IEEE P802.11

Title: Changes to the Infrared Baseband PHY in draft IEEE p802.11-93/20b3

This document proposes changes to the Infrared Baseband PHY described in section 12 of the current draft IEEE P802.11-93/20b3.

Figure 12.3.2. Emitter radiation pattern mask.

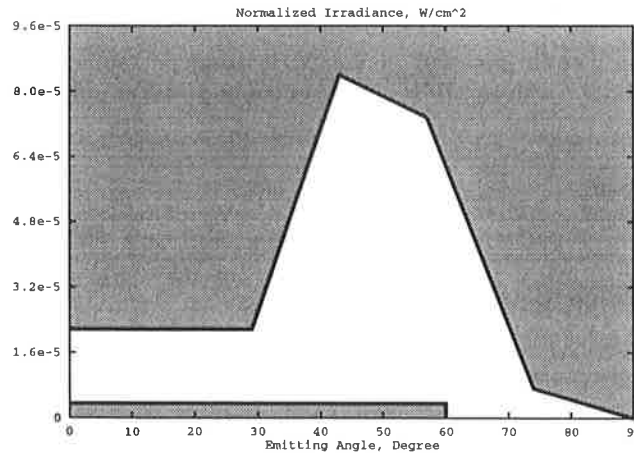
1. The Infrared Baseband Phy, Section 12 in the current draft IEEE P802.11-93/20b3 has a receiver FOV definition which is difficult to measure.
2. The Infrared Baseband Phy, Section 12 in the current draft IEEE P802.11-93/20b3 has no Transmit Spectrum mask specification.
3. The Infrared Baseband Phy, Section 12 in the current draft IEEE P802.11-93/20b3 has no figure of the Emitter Radiation Pattern mask.

1. Redefine receiver FOV specification.
2. Include Transmit Spectrum mask specification.
3. Include Emitter Radiation Pattern mask figure.

The emitter radiation pattern mask is defined in table 12.3.34.8. Position the conformant device in its recommended attitude. Define the conformant device axis as the axis passing through the emitter center and having the direction of the vertical from the floor. The mask represents the irradiance normalised to the average emitted power, as a function of the angle between the conformant device axis and the axis from the emitter center to the test receiver center (declination angle). The distance between emitter and test receiver is 1 meter. The test receiver normal is always aimed at the emitter center. The azimuth angle is a rotation angle on the conformant device axis.

DECLINATION ANGLE	NORMALIZED IRRADIANCE
$\alpha \leq 60^\circ$	$> 3.5e-6$
$\alpha \leq 22^\circ$	$\leq 2.2e-5$
$29^\circ < \alpha \leq 43^\circ$	$\leq -1.06e-4 + (0.44e-5) \alpha$
$43^\circ < \alpha \leq 57^\circ$	$\leq -1.15e-4 - (7.1e-7) \alpha$
$57^\circ < \alpha \leq 74^\circ$	$\leq 2.98e-4 - (3.9e-6) \alpha$
$74^\circ < \alpha \leq 90^\circ$	$\leq 4.05e-5 - (4.5e-7) \alpha$

Measurements at the following angles shall be made: declination angles from 0° to 90° in steps of 10°; at each declination angle for azimuth angles of 0°, 4°, 11°, 20° and 31°. A device is judged conformant if for all 10 declination angles the average of the irradiance over the 5 azimuth angles falls within the bounds of the emitter radiation pattern mask for any arbitrarily selected initial azimuth angle.
